**NOTICE OF A REGULAR MEETING
BONDURANT PLANNING AND ZONING COMMISSION
AUGUST 11, 2022**

**BUSINESS OF THE PLANNING AND ZONING COMMISSION
BONDURANT, IOWA
AGENDA STATEMENT**

TITLE: -RESOLUTION NO. PZ-220811-23: Considering recommended approval of the site plan at 3410 Henry Street SW

STUBBS ENGINEERING
431 NE 72ND ST. PLEASANT HILL, IA 50327
(515) 979-8499

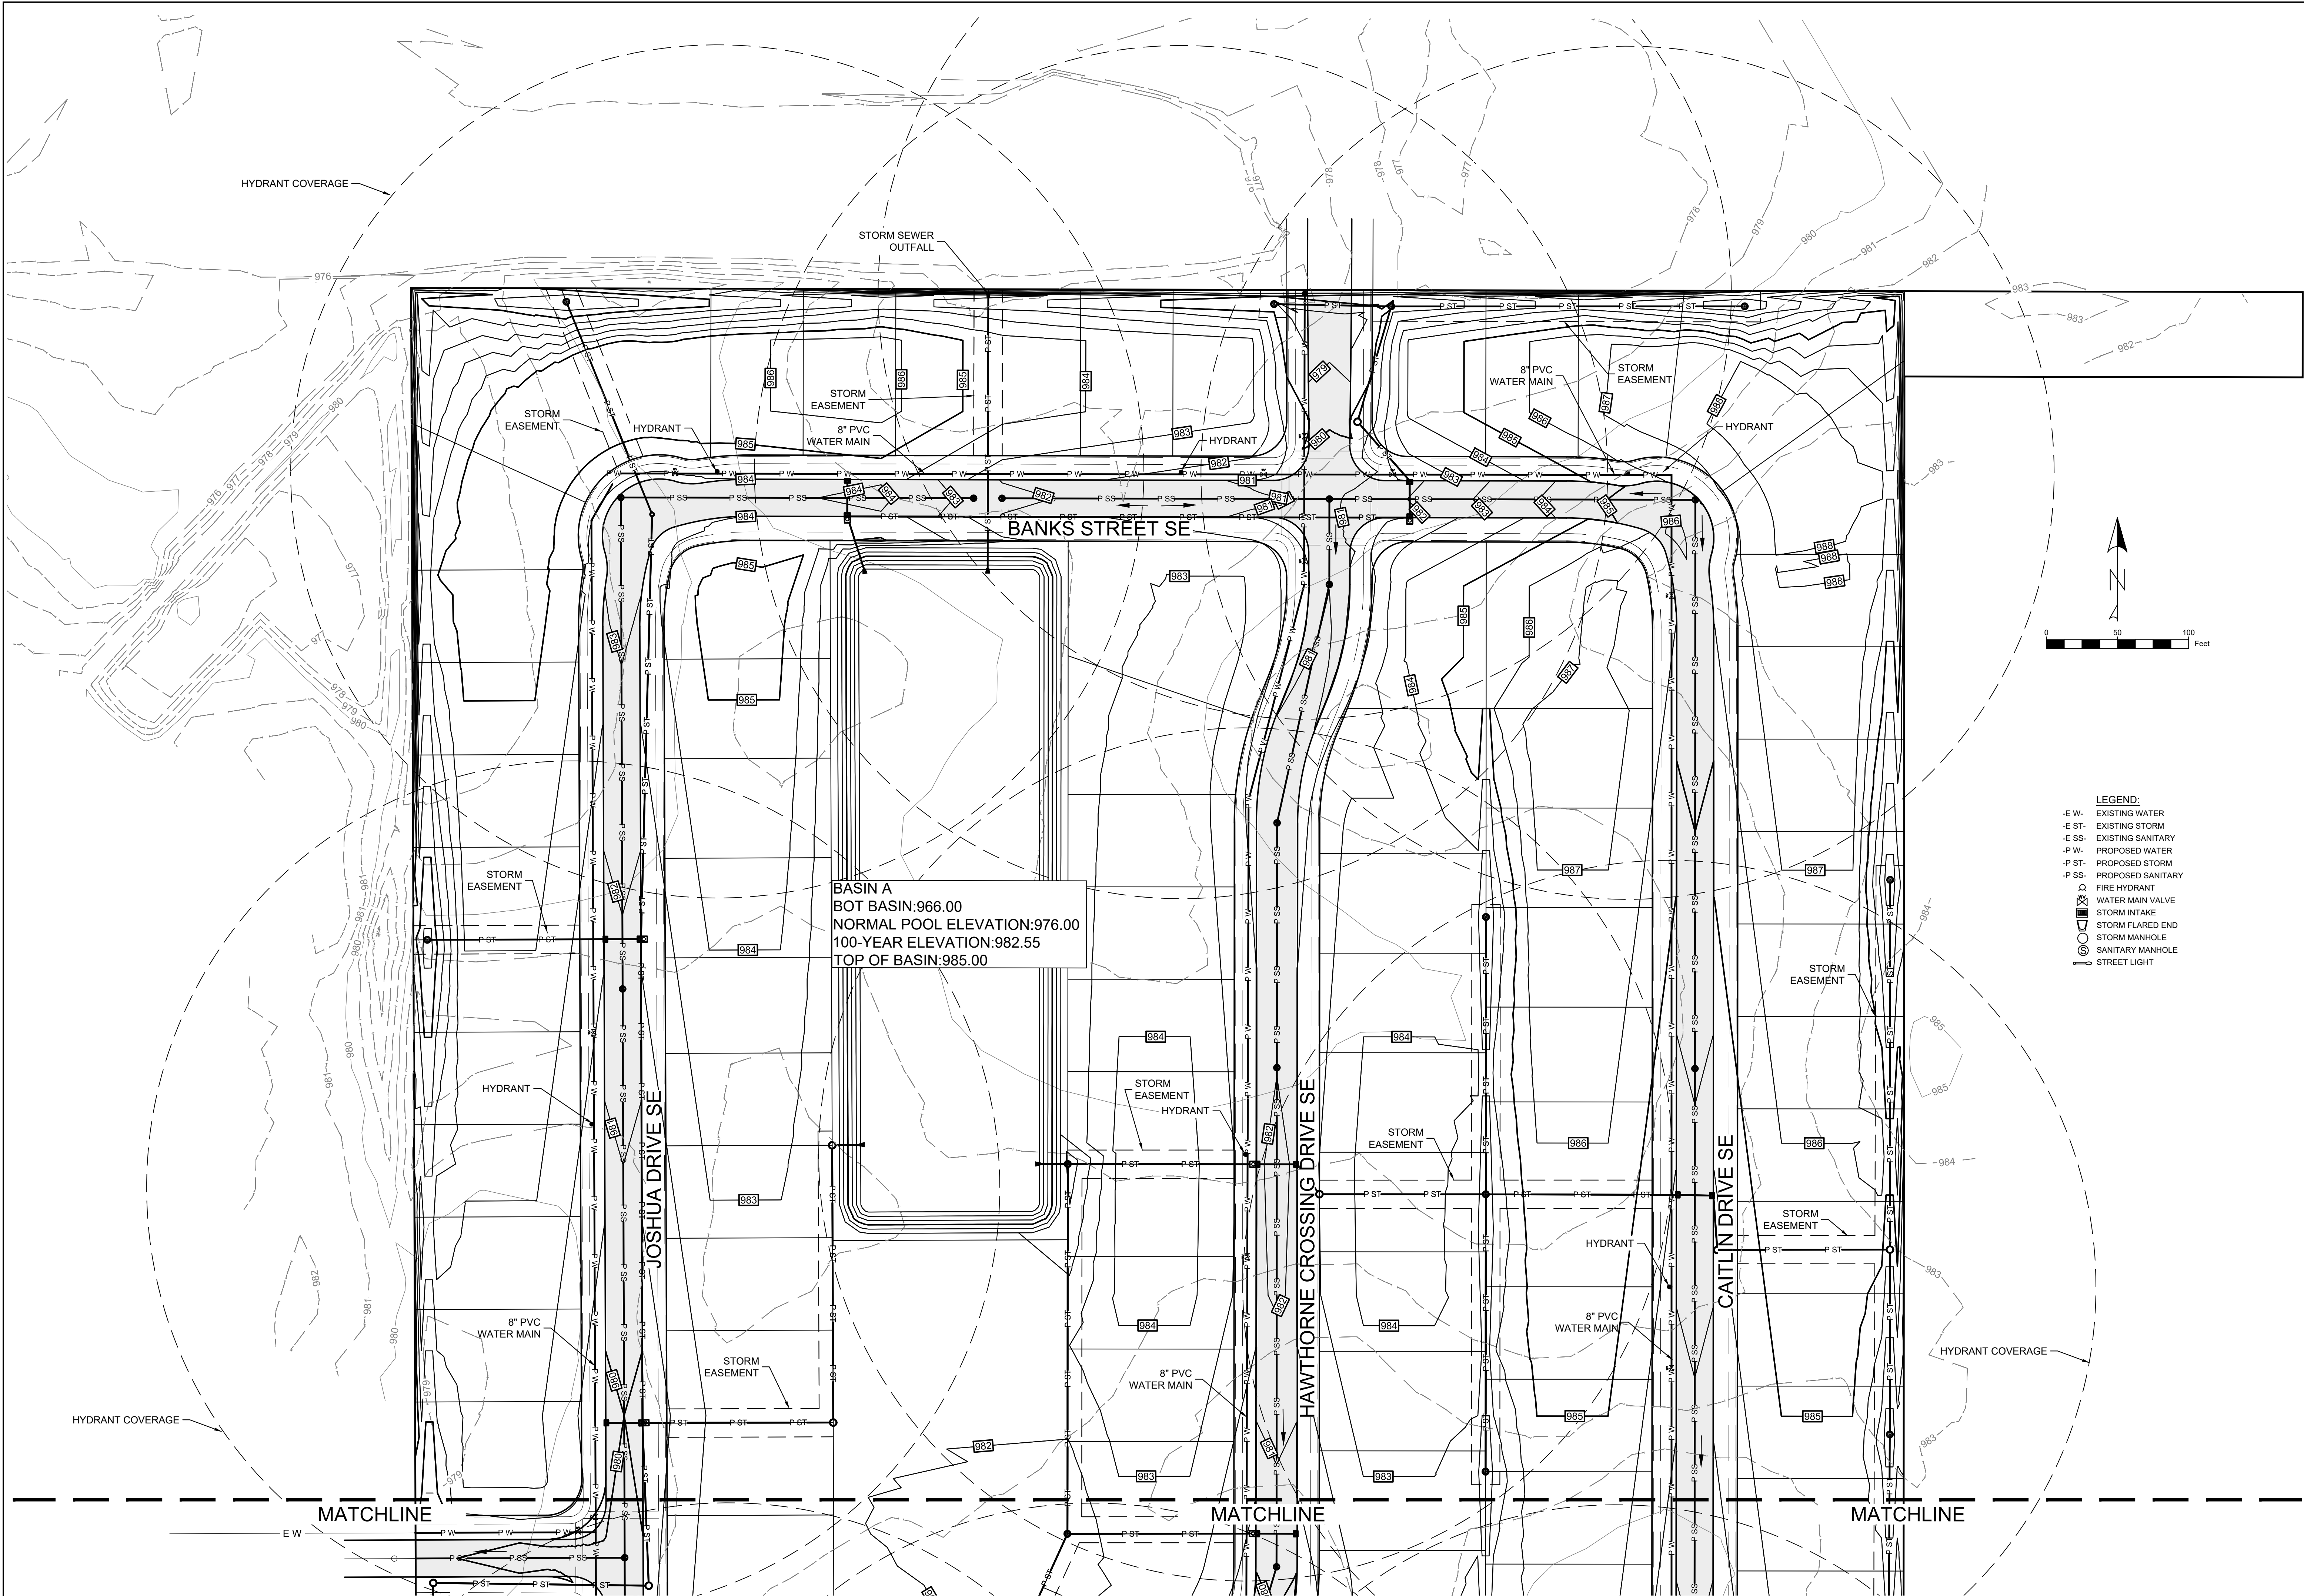
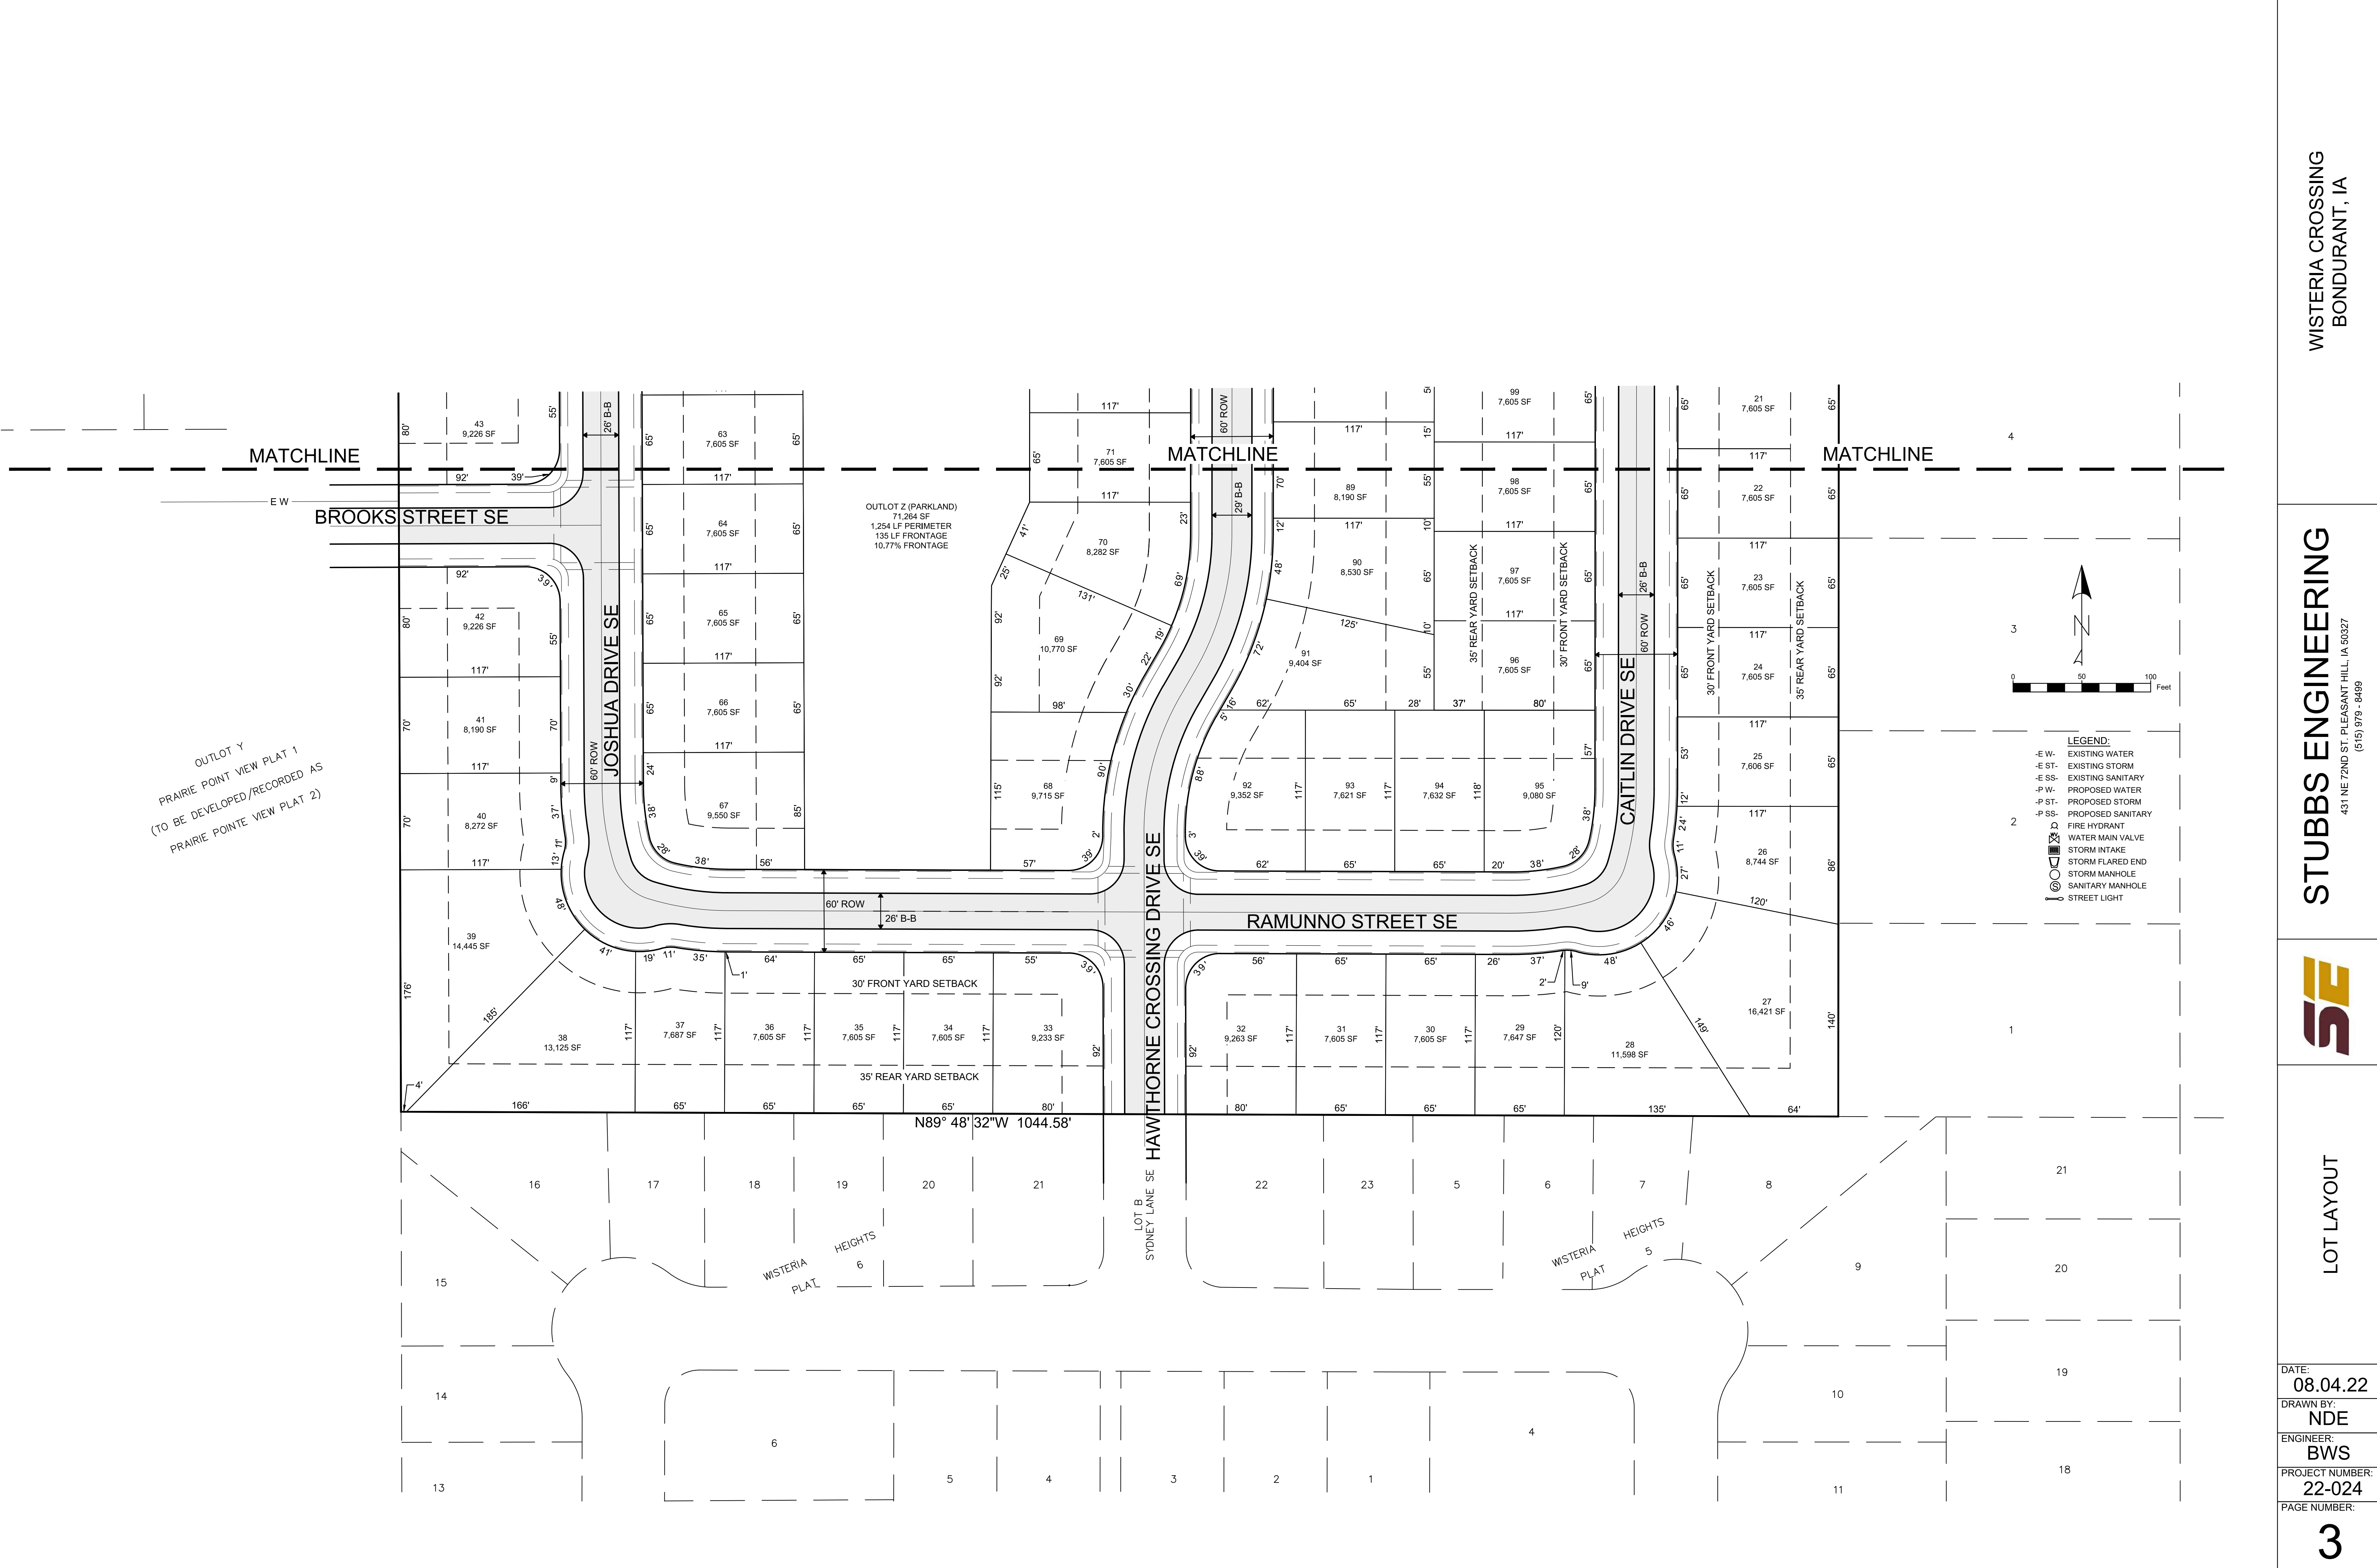
BRIEF HISTORY & ANALYSIS: The Planning & Zoning Commission tabled their review of the Wisteria Crossing Preliminary Plat during their meeting on July 28, 2022. The developer has since resubmitted the attached 3 versions of the Wisteria Crossing Preliminary Plat for the Commission's review. These options are summarized below.

- **Option 1** - this option proposes 109 lots. This option proposes one, 1.64-acre park with 10.77% of its park boundary fronting a public street. This 10.77% meets the Code's minimum requirement of 10%. This option does not show a street connection on Outlot W east over to Pleasant Street SE as requested by the Planning & Zoning Commission.

- **Option 2** - this option proposes 107 lots. This option proposes one, 1.64-acre park with 10.77% of its park boundary fronting a public street. This option does show a street connection on Outlot W east over to Pleasant Street SE as requested by the Planning & Zoning Commission.

- **Option 3** - this option 108 lots. This option proposes a 1.88-acre park with 22.65% of its park boundary fronting a public street. This option does not propose a street connection on Outlot W east over to Pleasant Street SE as requested by the Planning & Zoning Commission.
